ADDENDUM ONE
HIGHLAND PARK (ANDERSON AVENUE) GI DEMONSTRATION PROJECT
CONTRACT NO. S-11-001-201
CITY OF CHATTANOOGA, TENNESSEE

The following changes shall be made to the Contract Documents, Specifications, and Drawings:

III. Updates to Drawings

TRAFFIC CONTROL AND DEMOLITION PLAN
SHEET: 00C-102

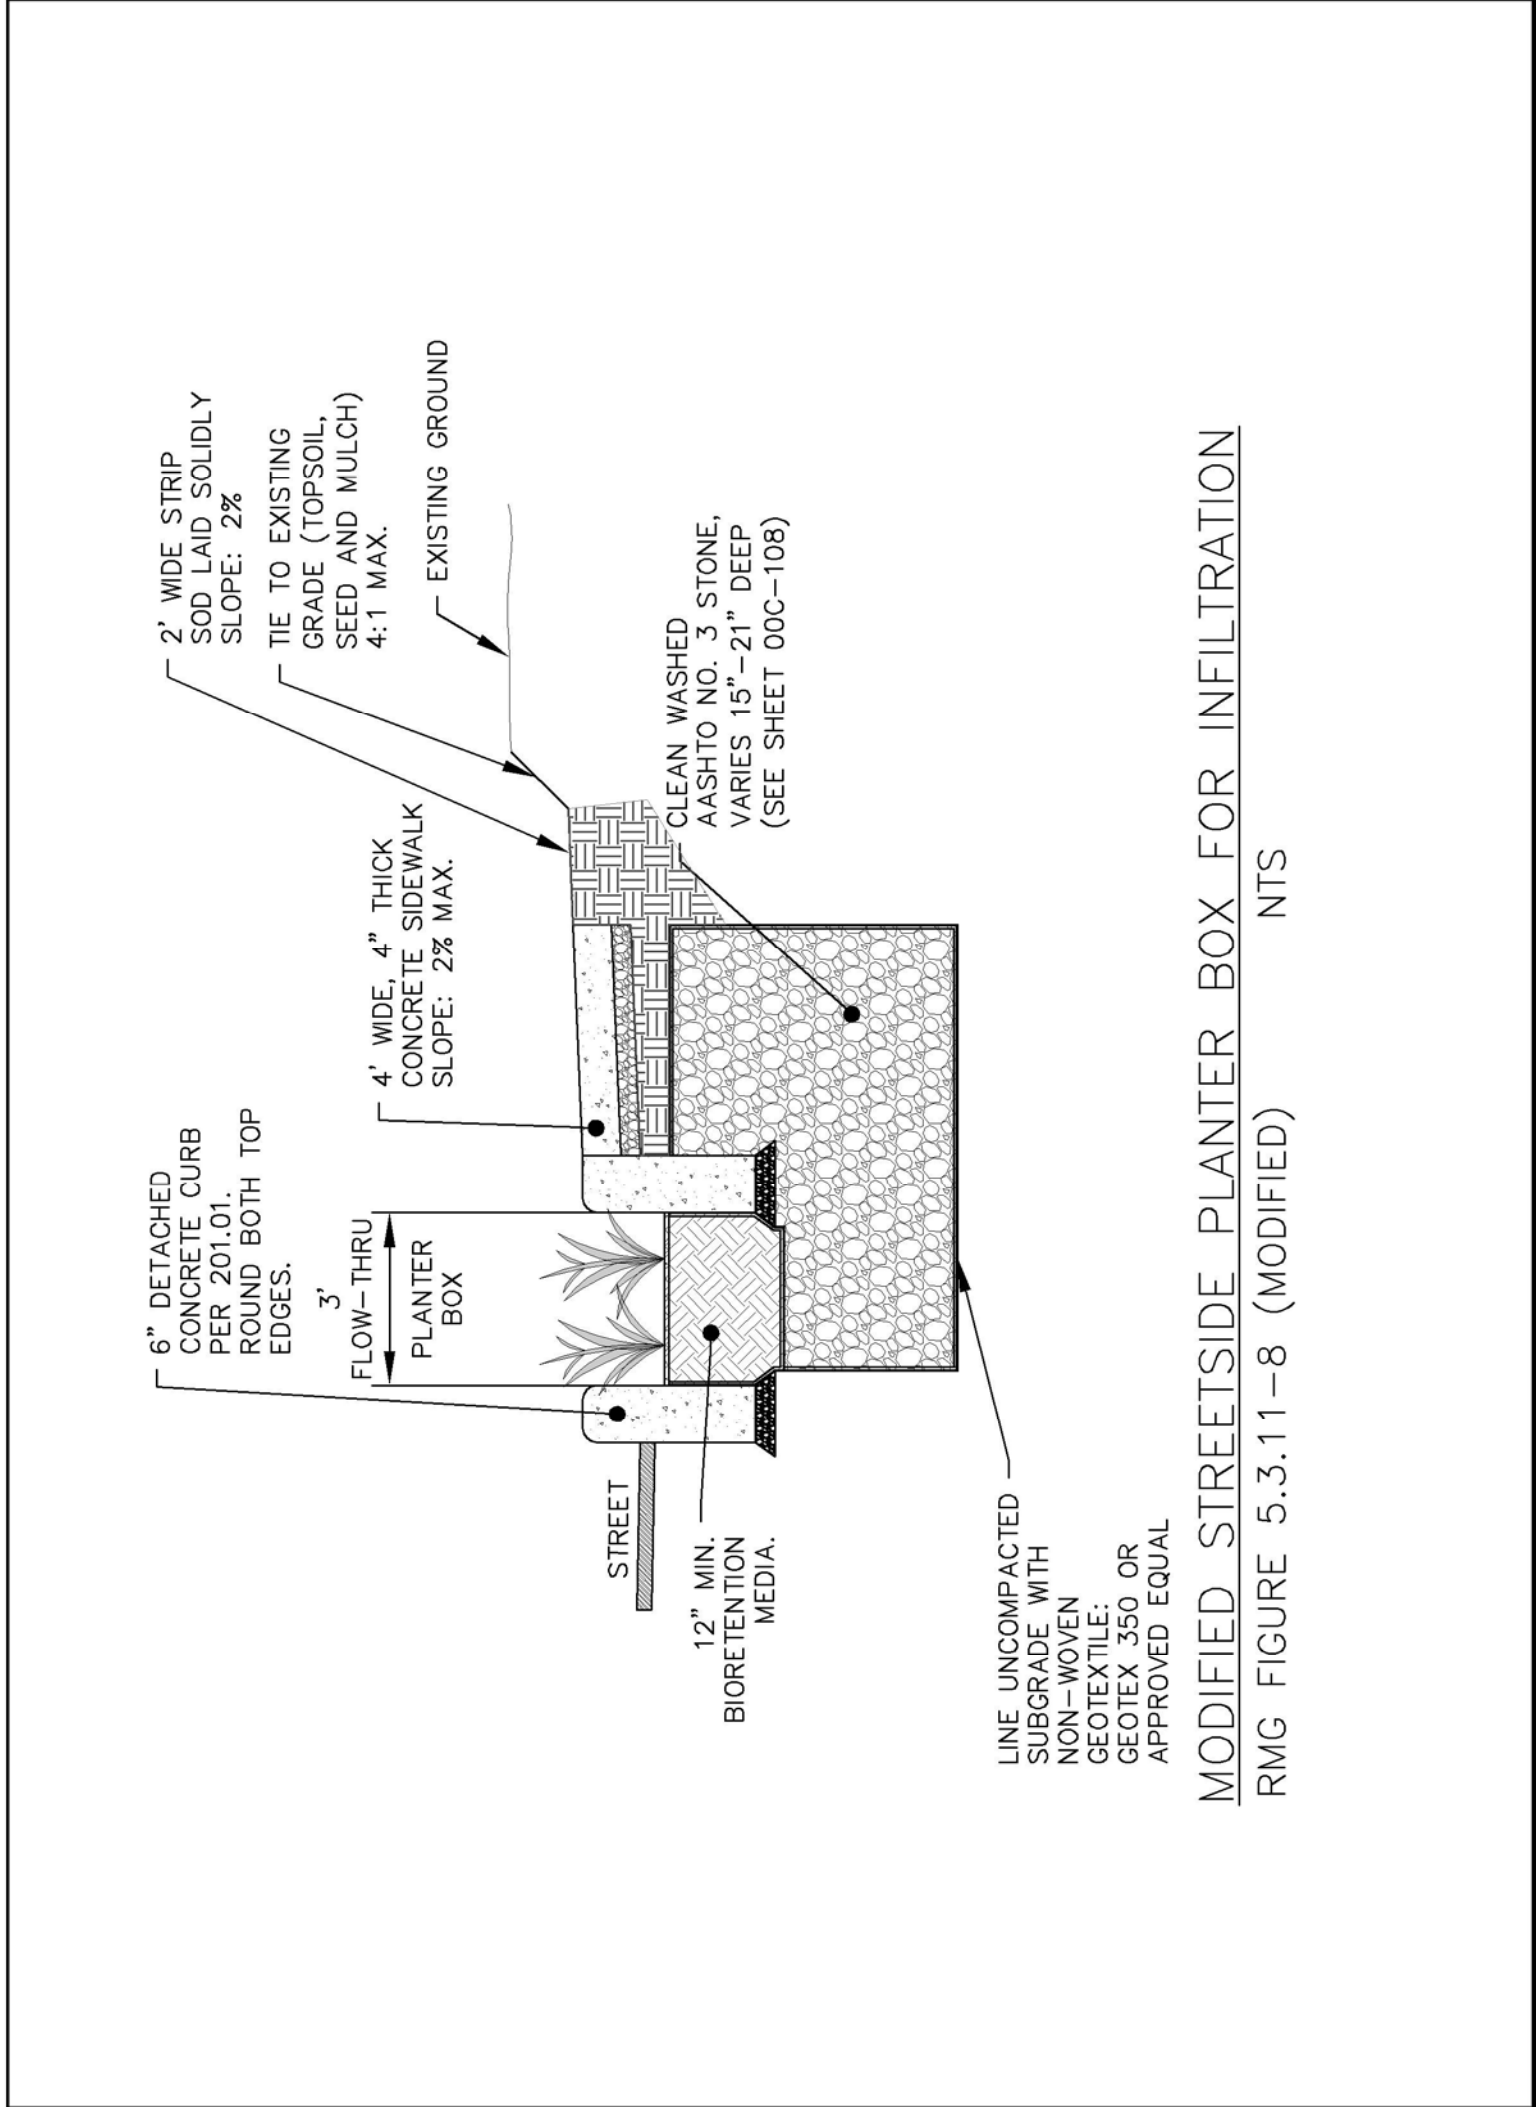
Sht 00C-102 Traffic Control Plan and demolition has been updated

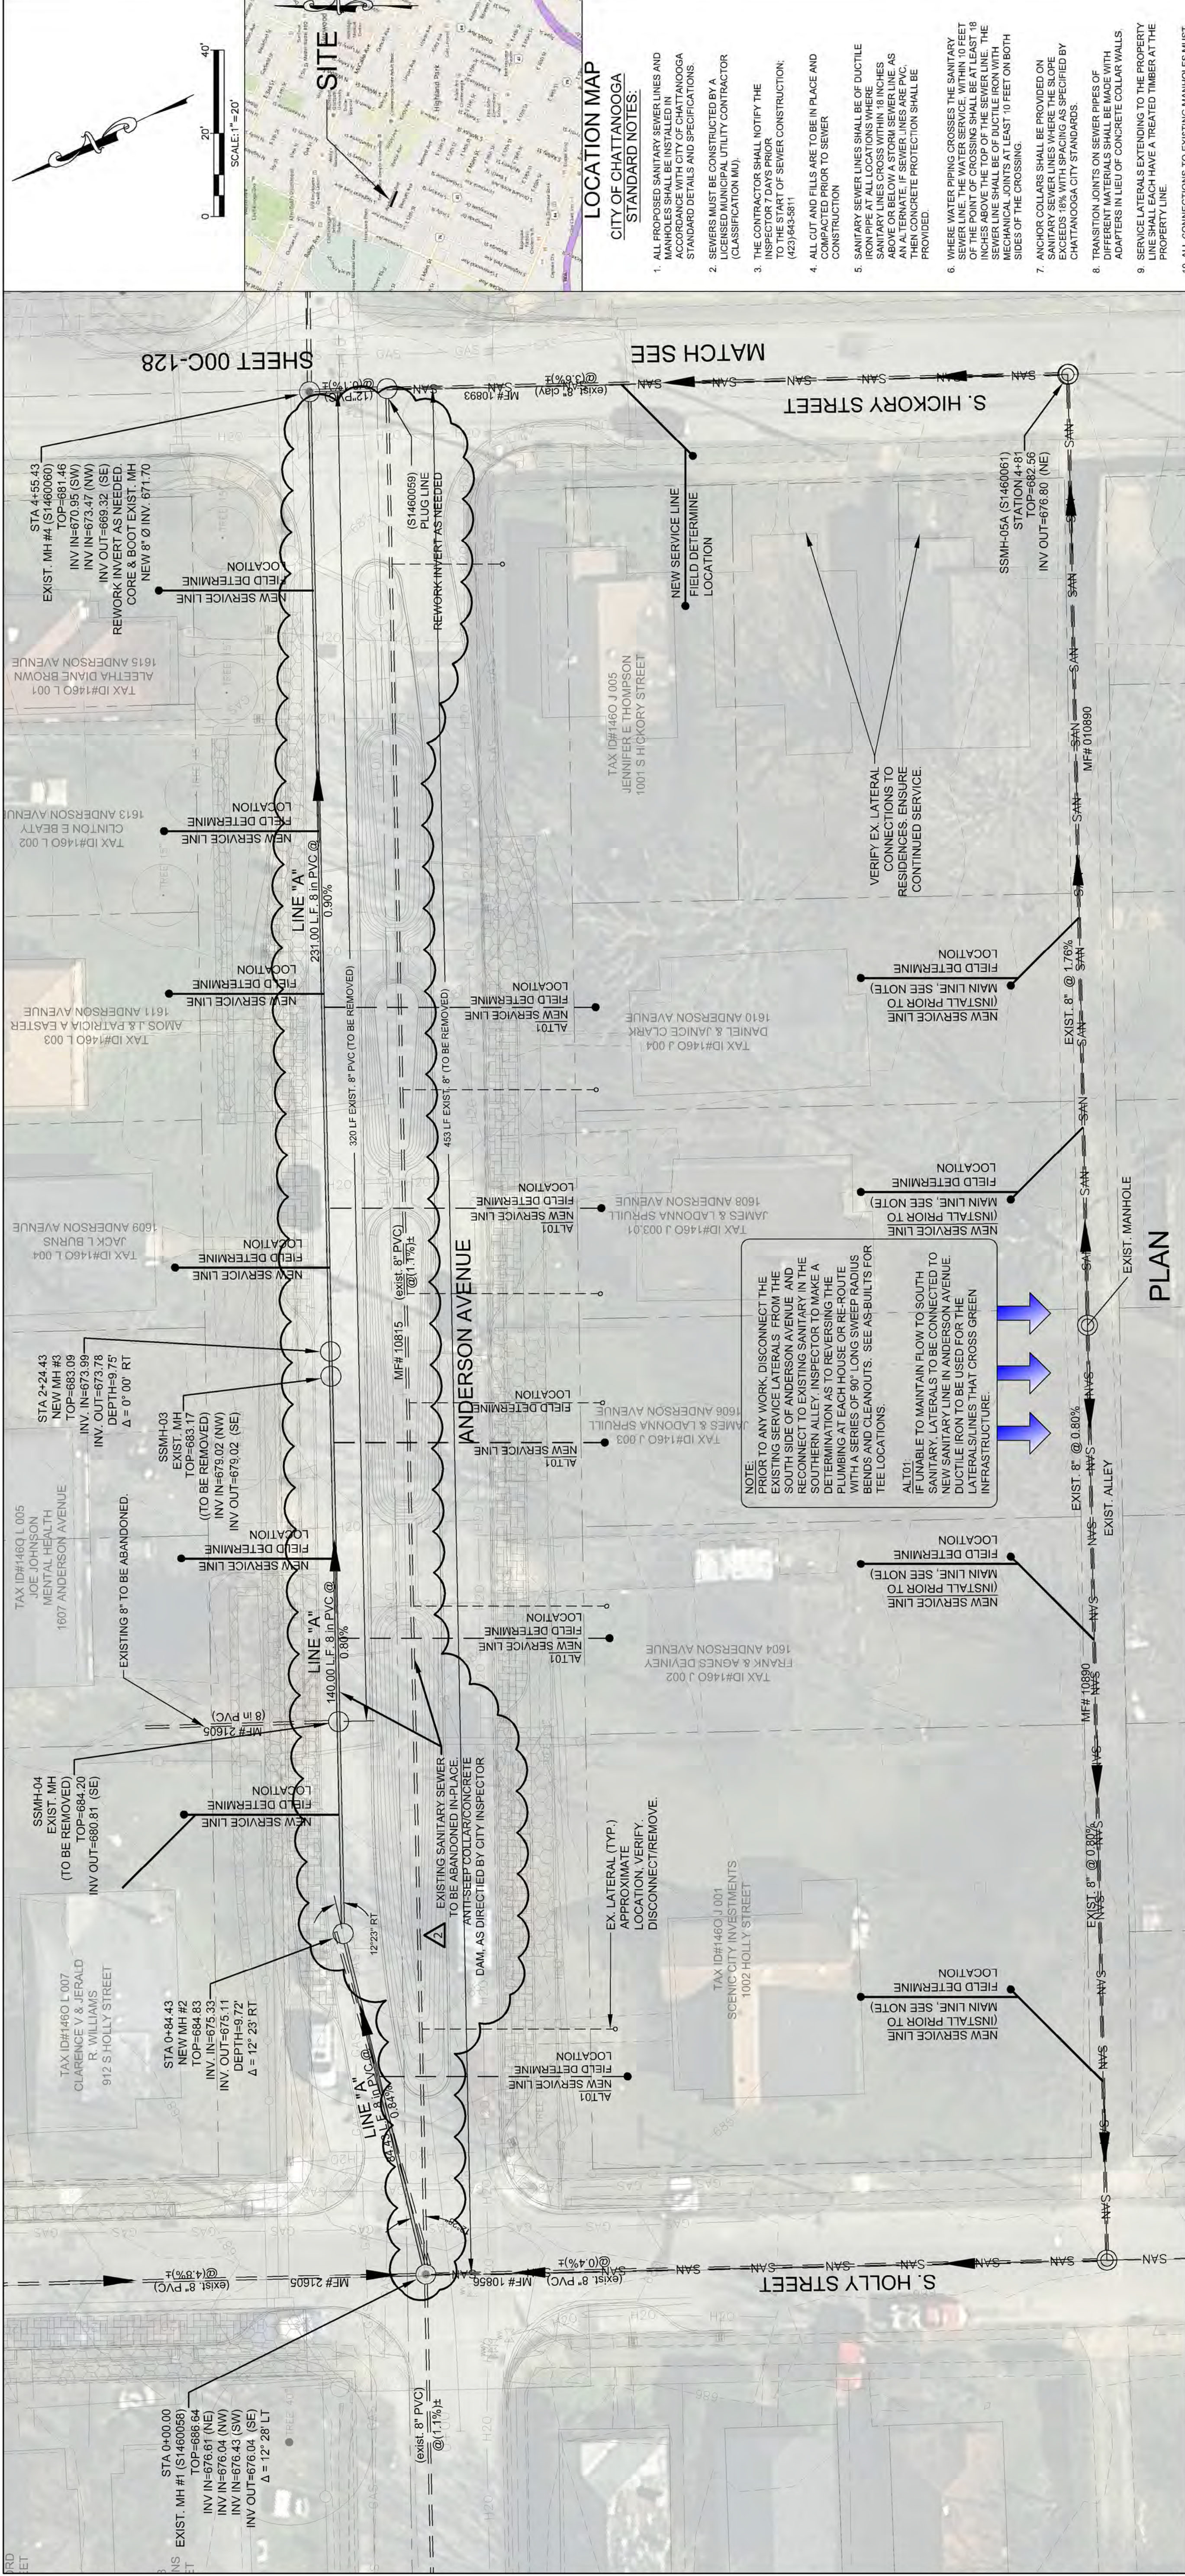
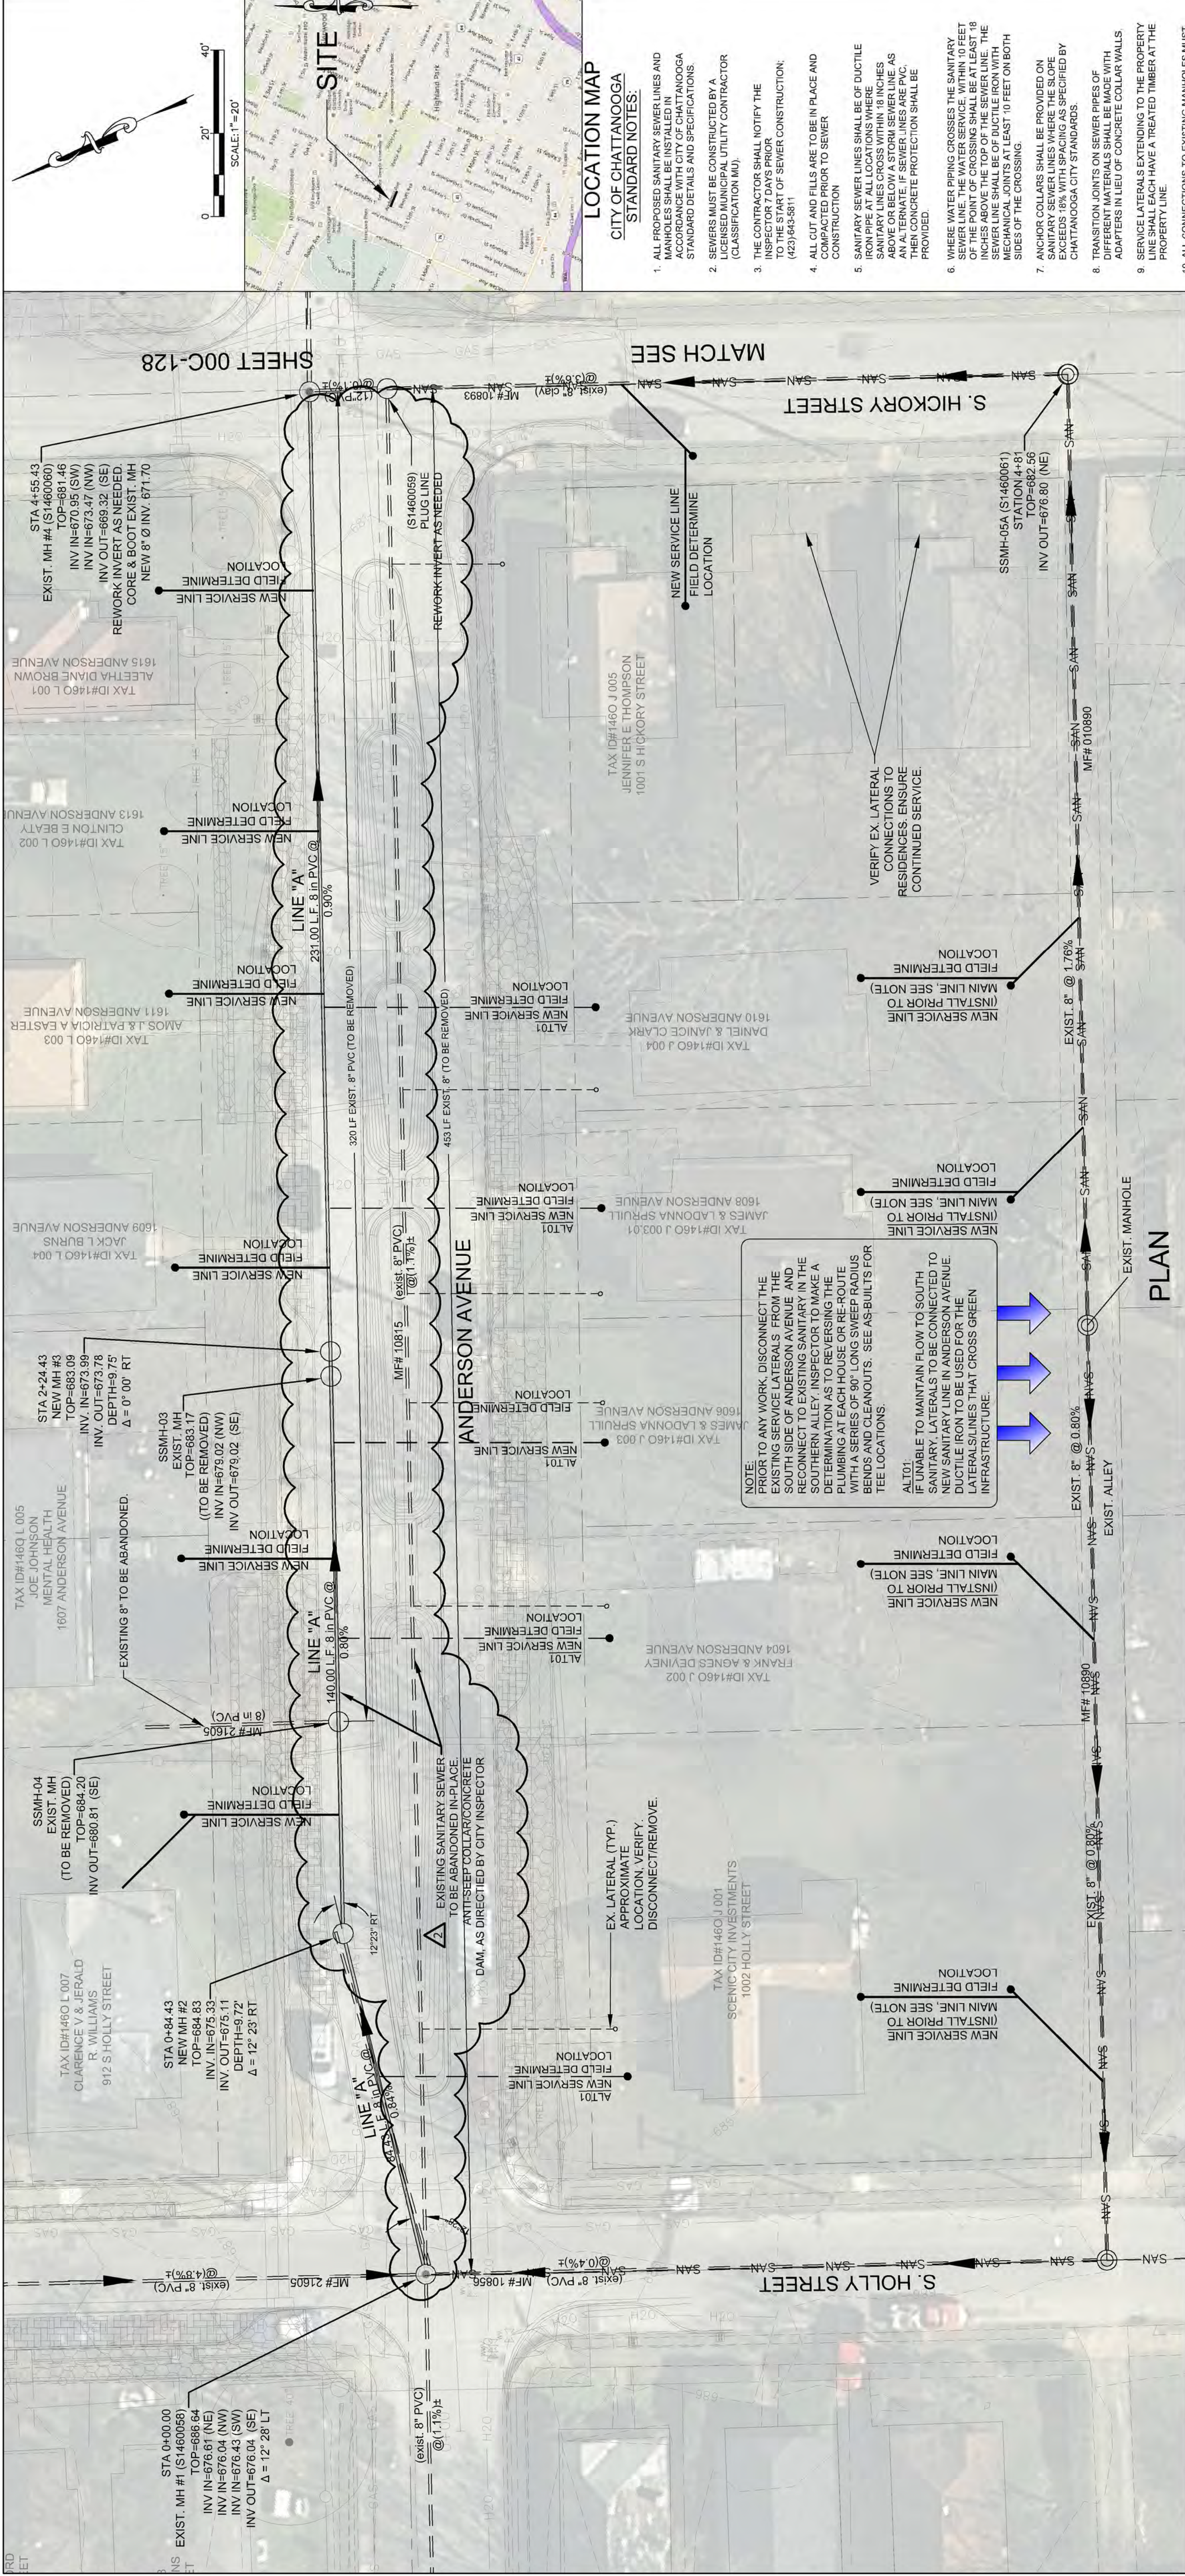
Q? There is no detail provide for the modified Handicap Ramp. Can you please provide a detail?

Sht 00C-115 Observation Well Detail updated, modified HC ramp detail added

A. Modified Handicap Ramp detail added to OOC-115.
